# Access Compliance Report

## Public Rights-of-Way

Intersection ID: 30082	Main Street: VILLAGE SHOPPING CENTER DR N	Cross Street: J W CLAY BV	Location: NE
ADA ID: 2CA96870304E	Ramp Type: PerpDiag	Initial Pass/Fail: Fail	Overall Compliance: No
Severity Score: 31.25			
Codes/Mitigation Info/Possible Solution		Field Measurements/Component Compliance

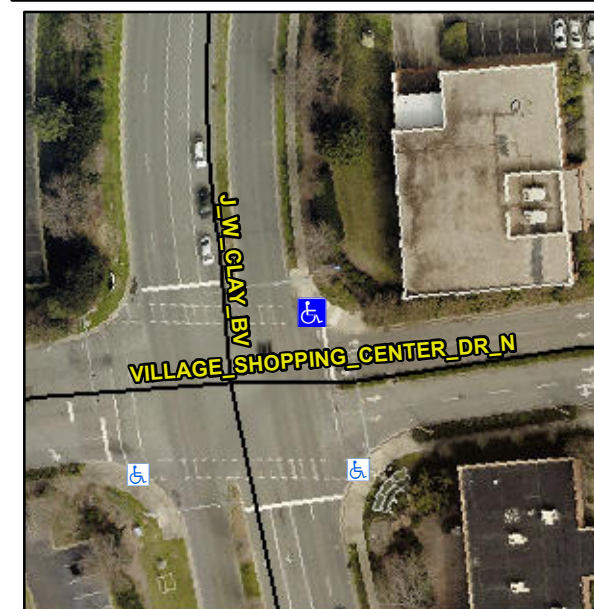
Compliance	Description	Data	Compliance	Description	Data
N/A	Ramp Length (in)	117.0	No	Ramp Slope (%)	9.0
No	Ramp Width (in)	32.0	No	Ramp XSlope (%)	2.8
N/A	Flare Type LT	N/A	N/A	Flare Type RT	N/A
N/A	Flare Slope LT (%)	N/A	N/A	Flare Slope RT (%)	N/A
N/A	Flare Traversable LT?	N/A	N/A	Flare Traversable RT?	N/A
N/A	Landing Length (in)	N/A	N/A	DWS Provided?	N/A
N/A	Landing Width (in)	N/A	N/A	DWS Contrast?	N/A
N/A	Landing Slope (%)	N/A	N/A	DWS Length (in)	N/A
N/A	Landing X Slope (%)	N/A	N/A	DWS Full Width?	N/A
N/A	Landing Curb? (Y/N)	N/A	N/A	DWS Offset (in)	N/A
N/A	Shared Landing?	N/A			
N/A	Gutter Ponding?	N/A	N/A	Gutter Slope (%)	N/A
N/A	Gutter Lip Ht (in)	N/A	N/A	Gutter X Slope (%)	N/A
N/A	Painted X Walk1?	Yes	N/A	Painted X Walk2?	Yes
	X Walk 1 Direction	To W		X Walk 2 Direction	To S
N/A	X Walk 1 Width (in)	103.0	N/A	X Walk 2 Width (in)	108.0
	X Walk 1 Slope (%)	2.9		X Walk 2 Slope (%)	0.2
	X Walk 1 X Slope (%)	0.5		X Walk 2 X Slope (%)	2.1

N/A	Ramp inside XWalk1?	Yes	N/A	Ramp inside XWalk2?	Yes
	Road Slope (%)	0.1	N/A	Clear Space?	N/A
	Road X Slope (%)	4.1	N/A	Clear Space to XWalk (in)	N/A
N/A	Any Obstructions?	N/A	N/A	Storm Grate/Utility Hazard?	N/A
	Obstruction Type			Storm Grate/Utility Type	
		N/A			N/A
		Yes		Surface Condition? (G/P)	Good

**Remove & Replace Curb Ramp With Two New Directional Ramps or Equivalent.**
